Explanation of Request: Construction of a new manufacturing facility for Sintavia.

**RE: SITE PLAN REVIEW – N.E. Corner of SW 25th Avenue & North of SW 39th Street
FILE NUMBER 17-DPV-33**

Please find below the Site Plan Review case review comments and our written responses for the referenced project.

Scale: 1"=20'	Date 05/18/17
Job No. 17-1365.00	Plot Date 06/30/17
Drawn by FES	Sheet No. C1
Proj. Mgr. FES	
Appr. by JMF	
1 of 4

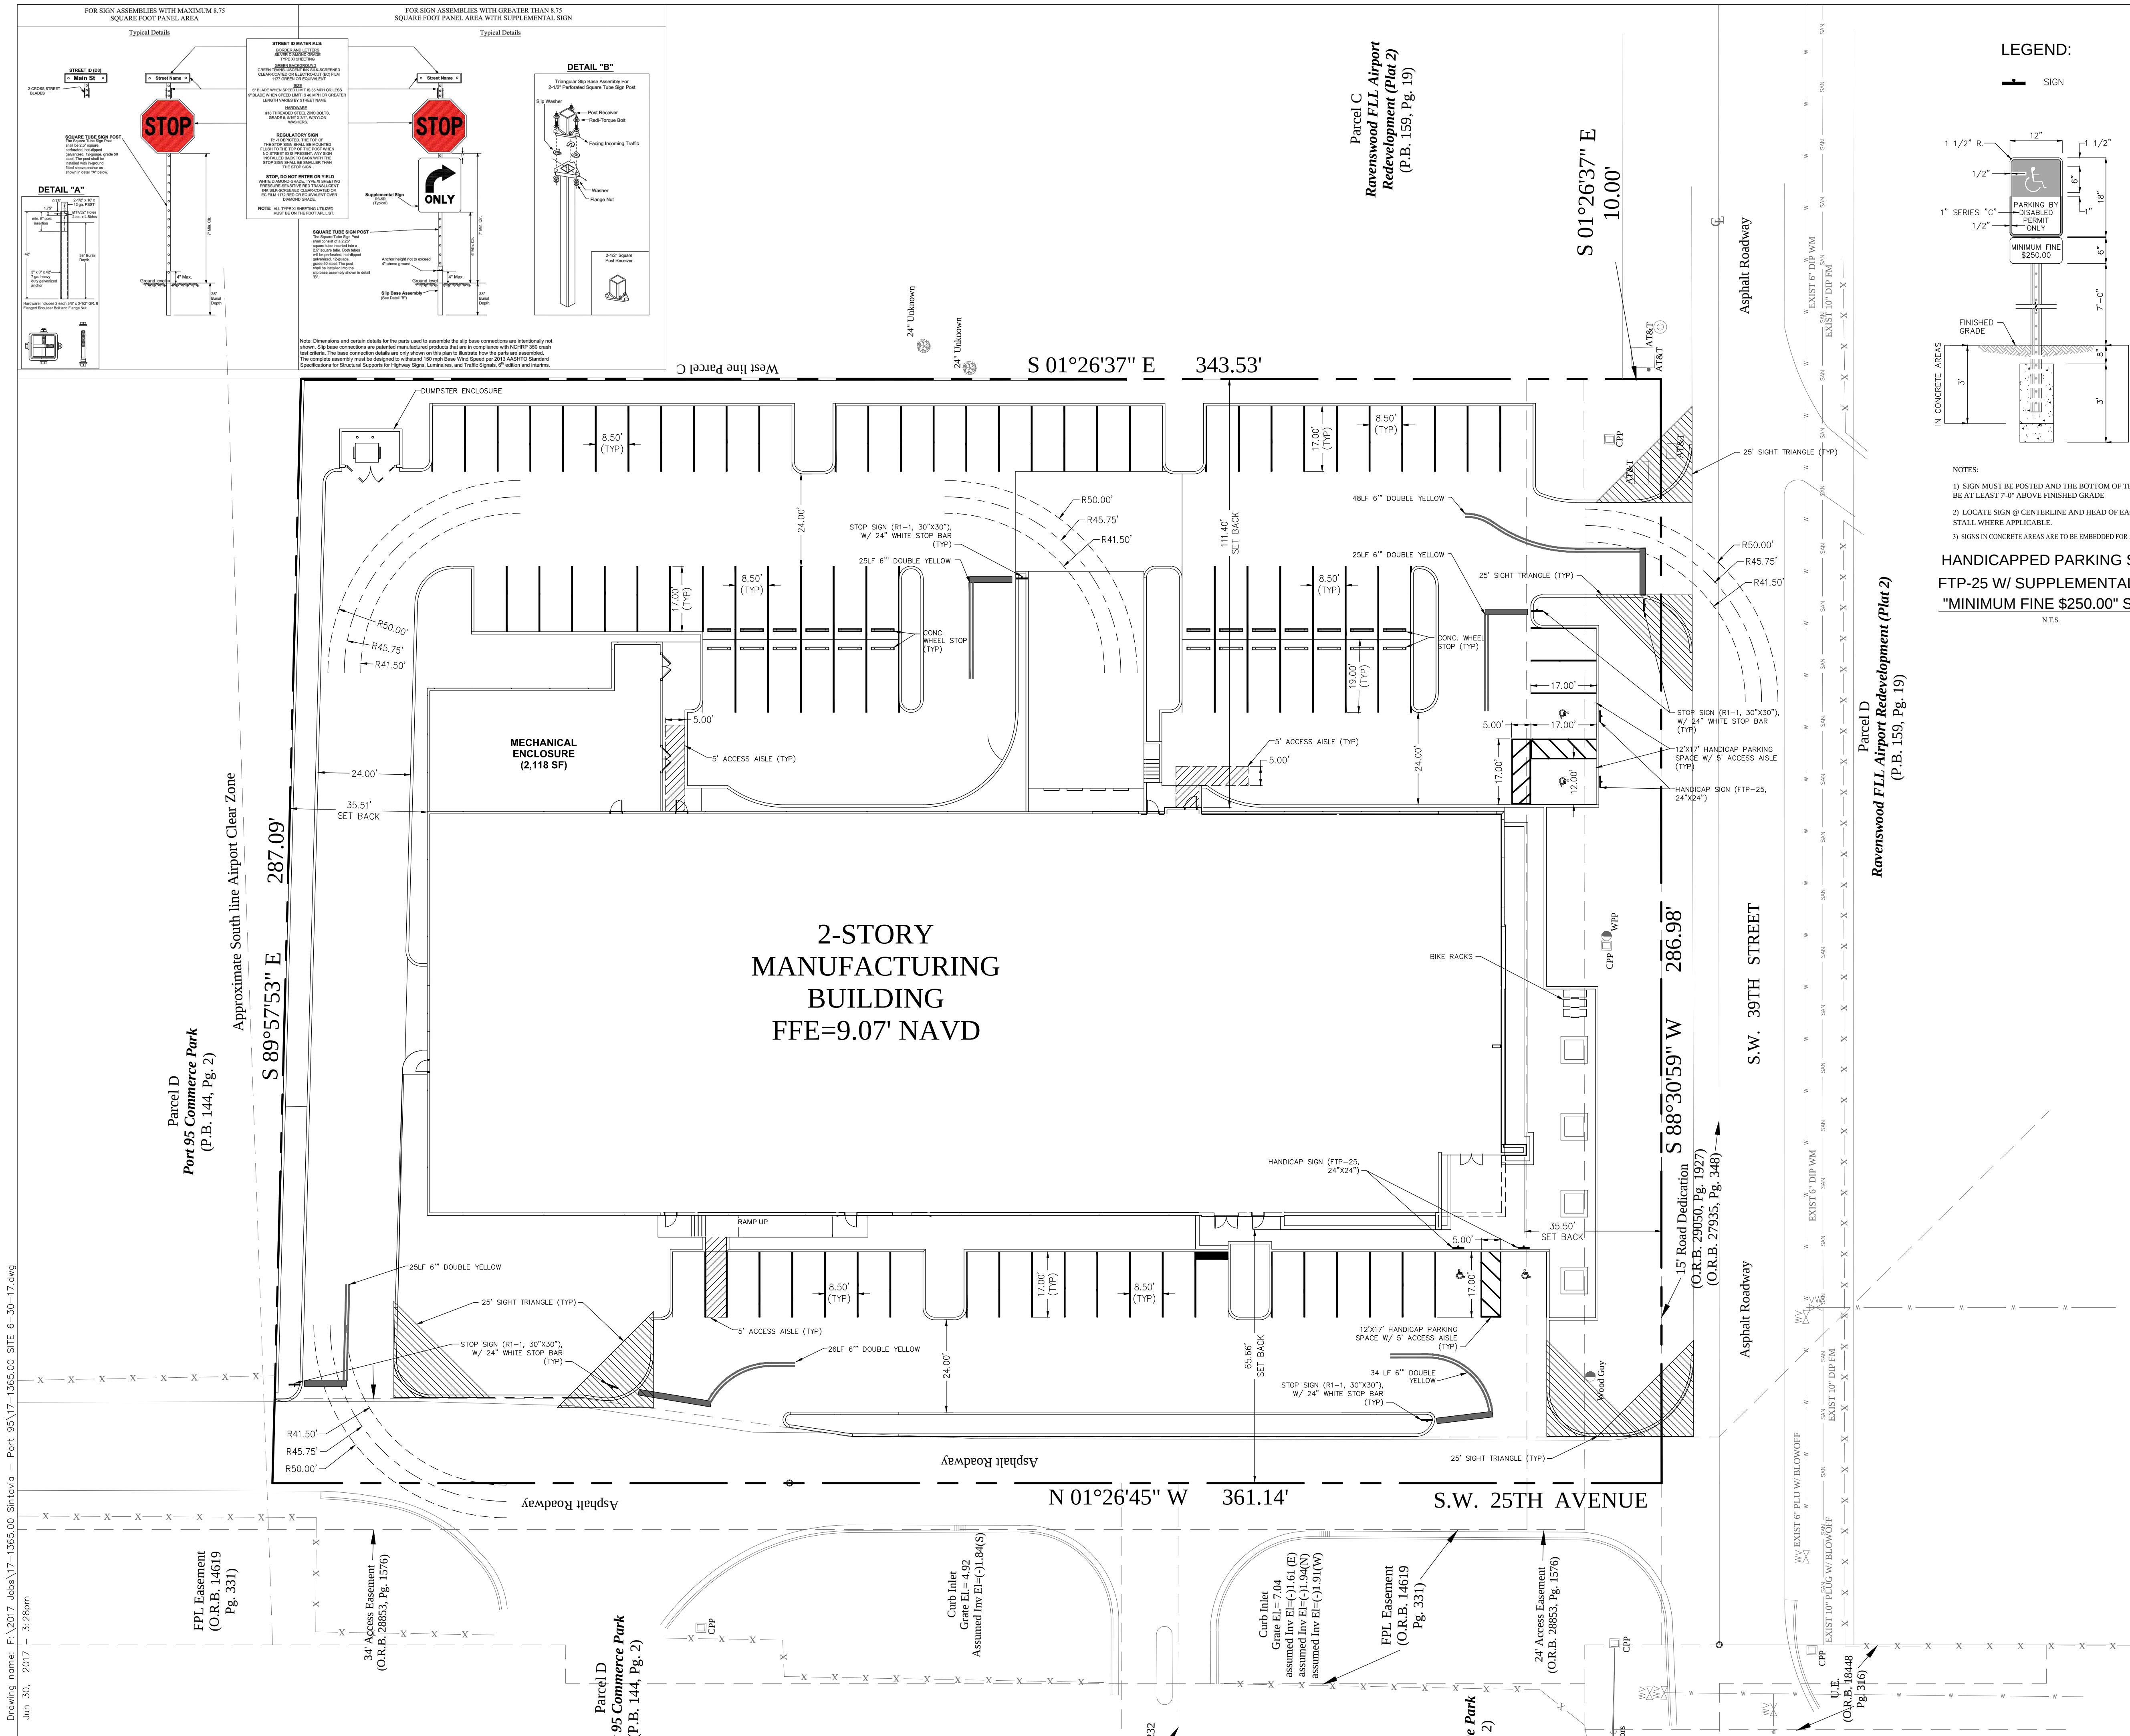
2. Provide water and sewer demand calculations on the water and sewer plans.

Response: See revised plan, Sheet C1.

A-101.1

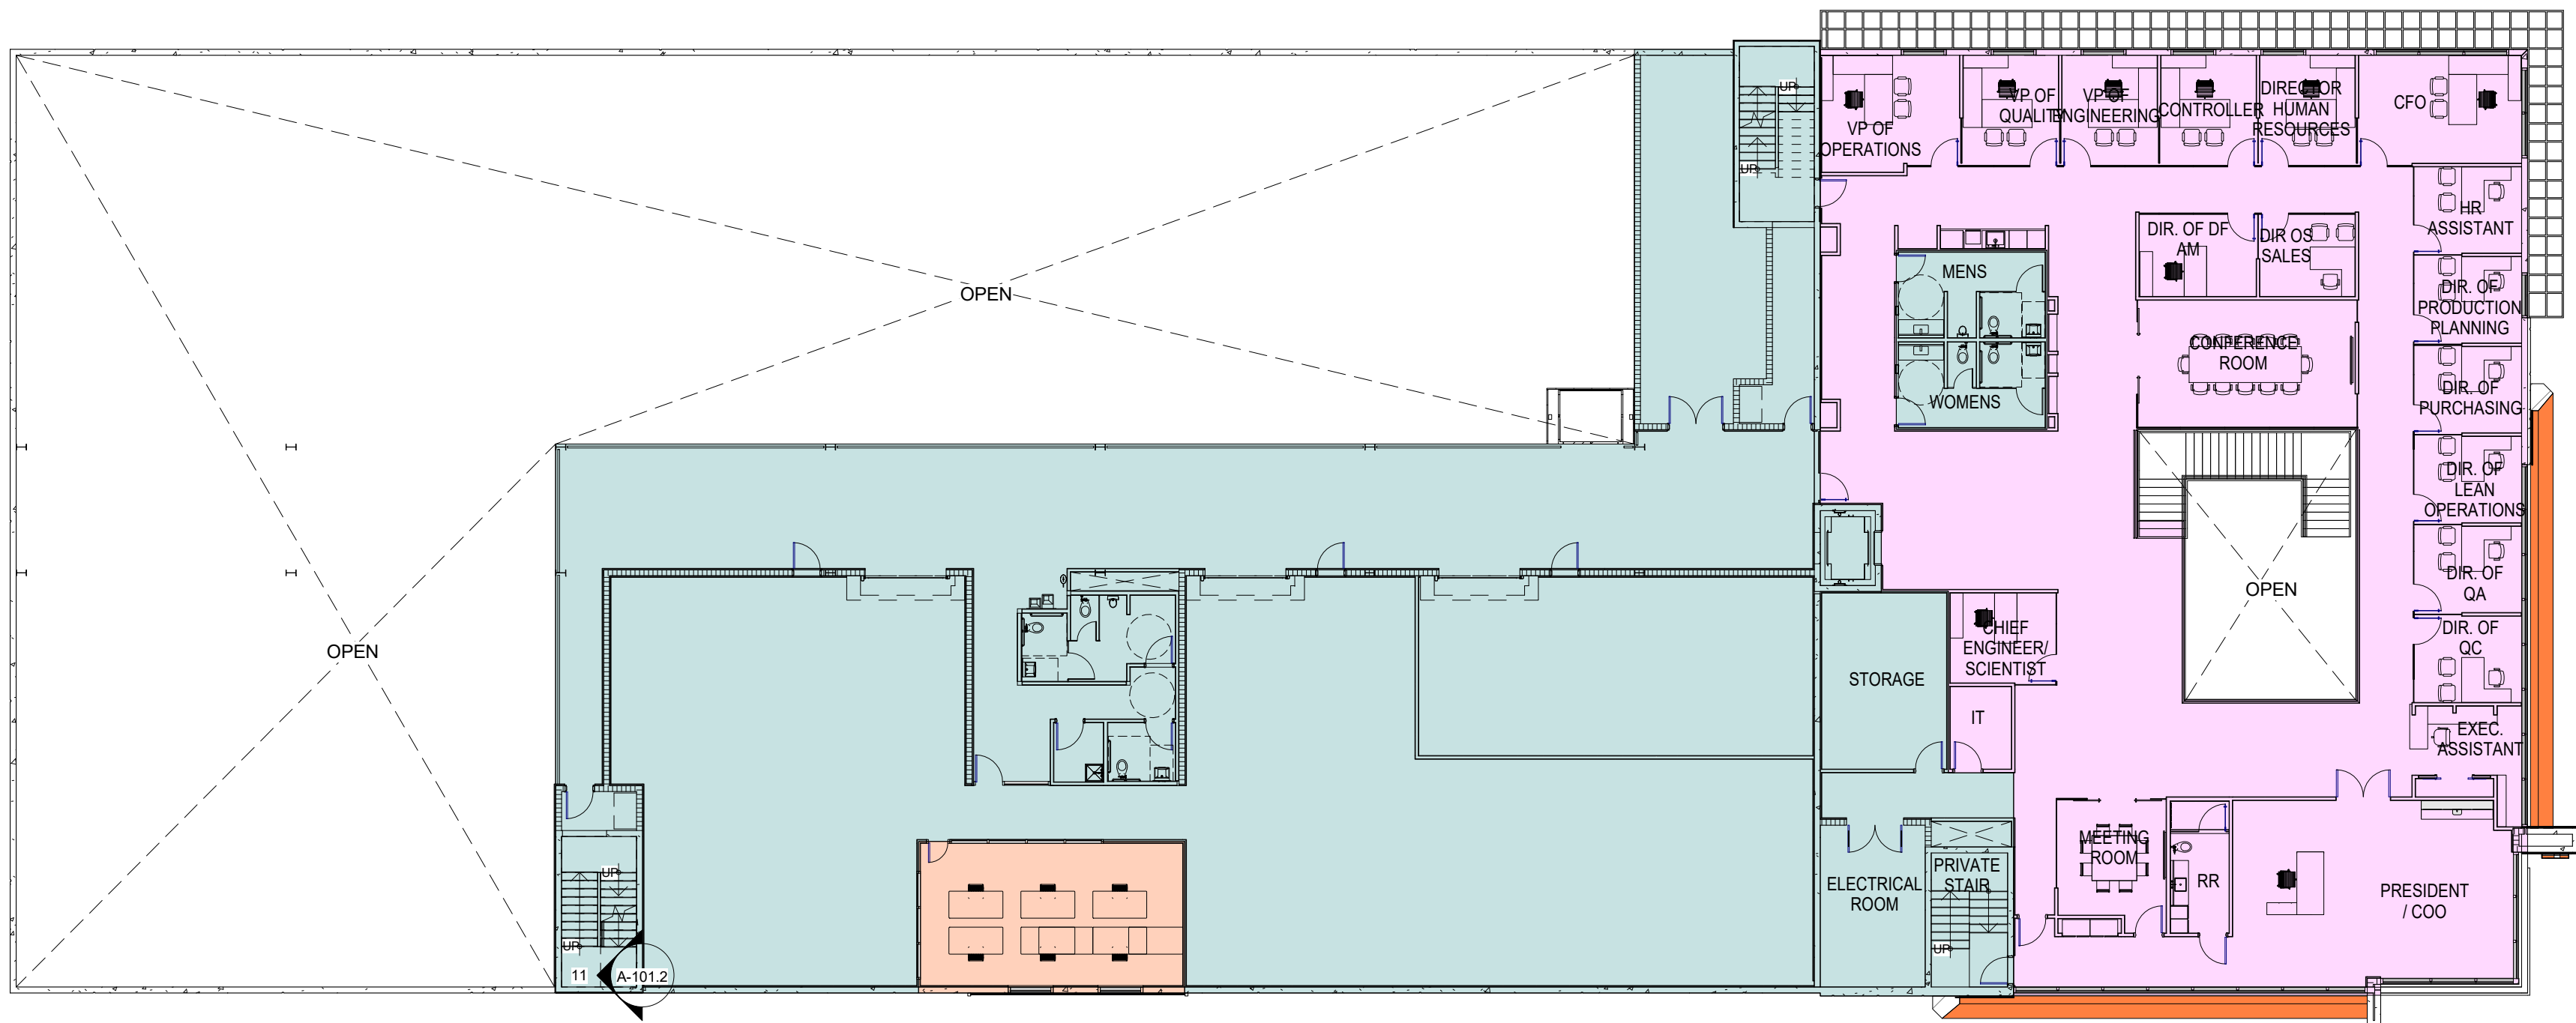
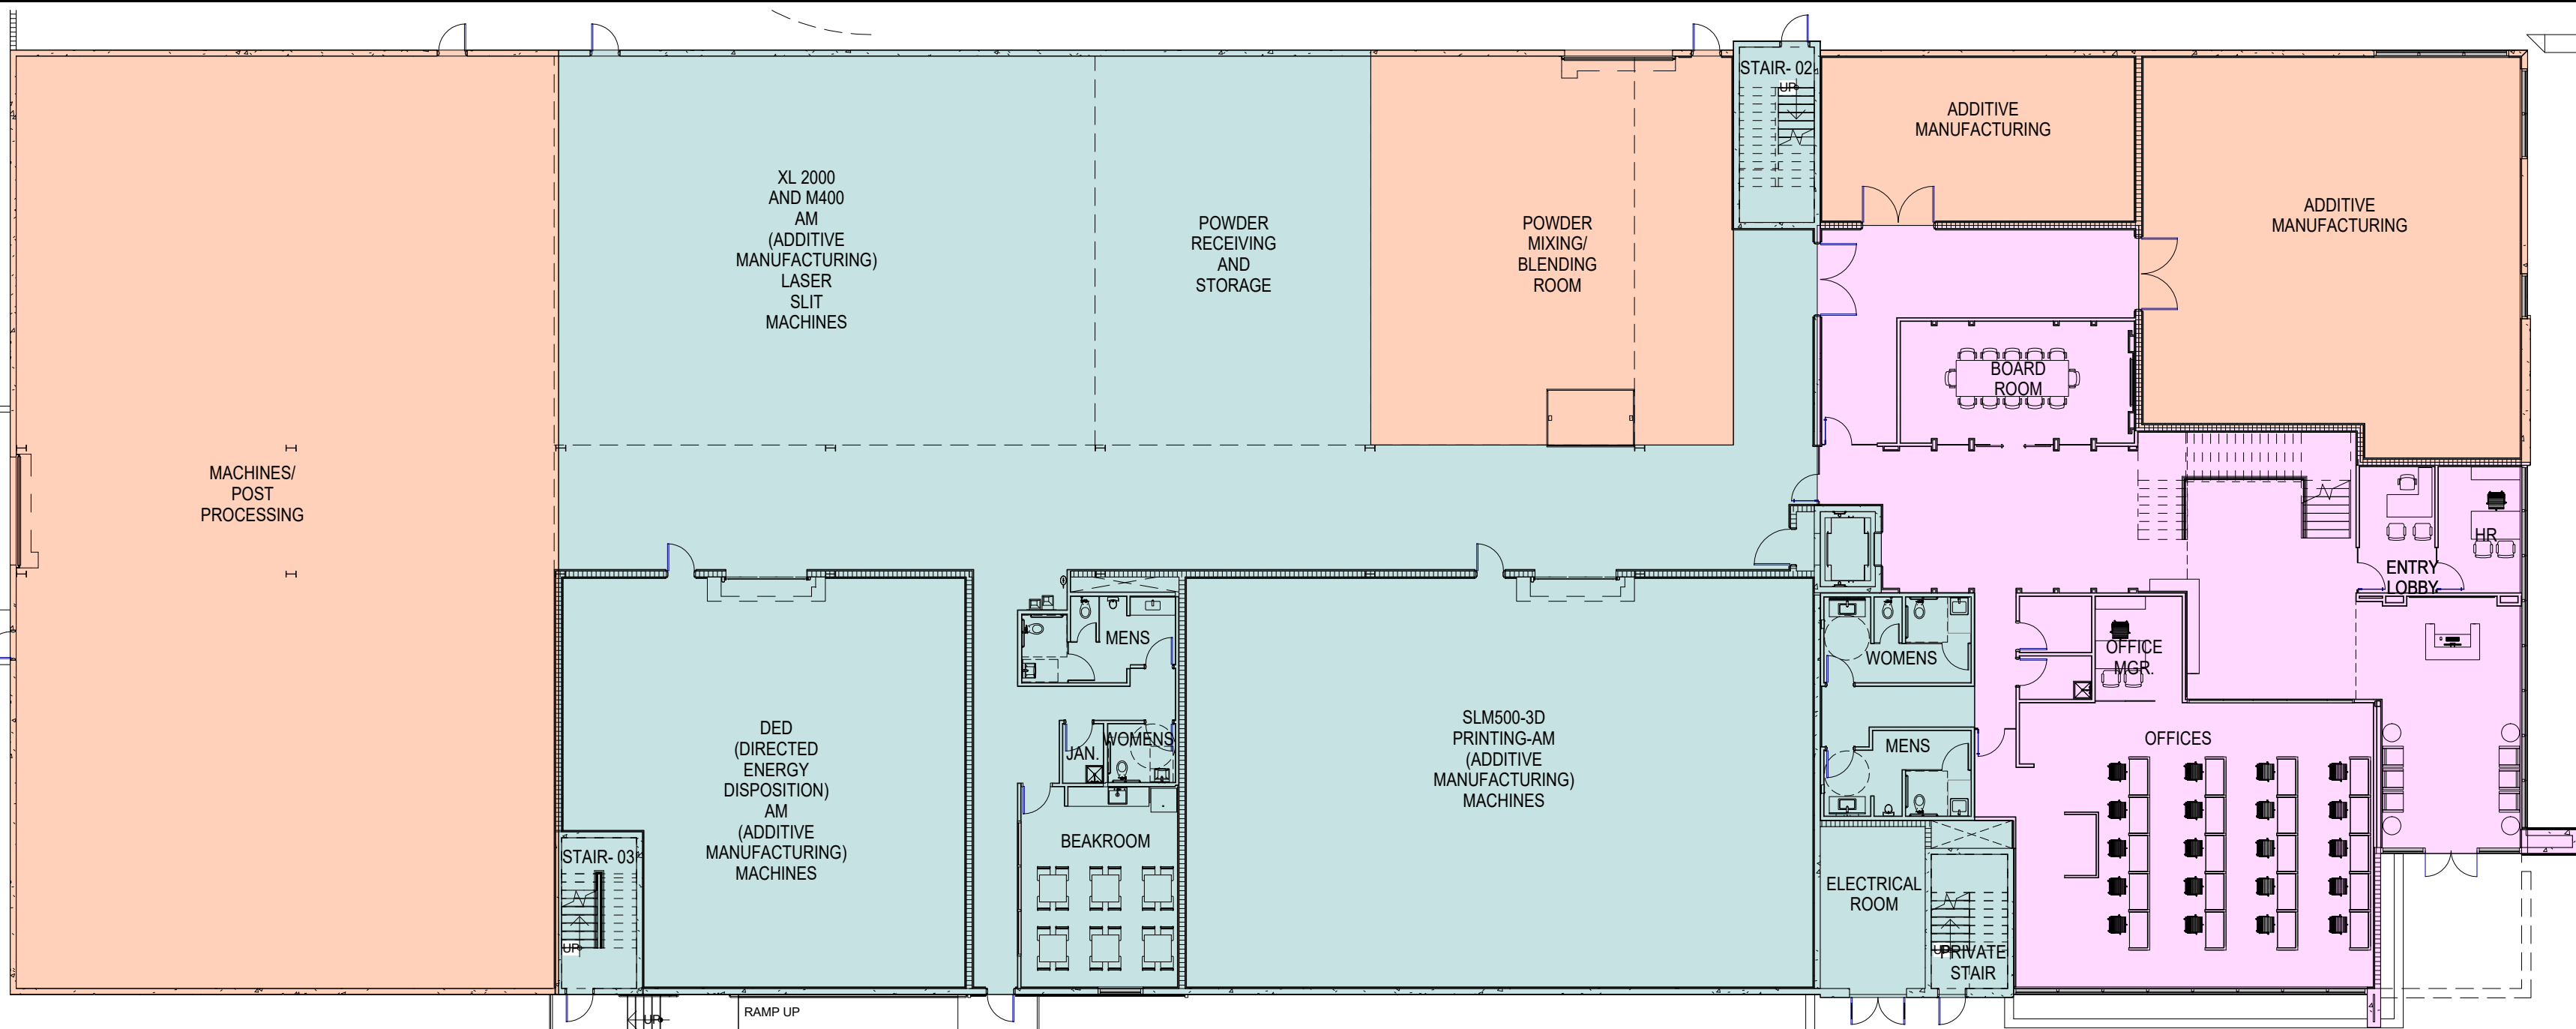
2. Some of the processes shown on the floor plan pg. A-101.1 may require special fire protection systems. It would behoove you to work with a design consultant experienced in these types of system to identify now any special hazard requirements or special requirements for the fire sprinkler system.

Response: *Understood, we are in the process of working with our Fire Protection Engineer to develop a fire protection system that will satisfy the needs of the Owner.*
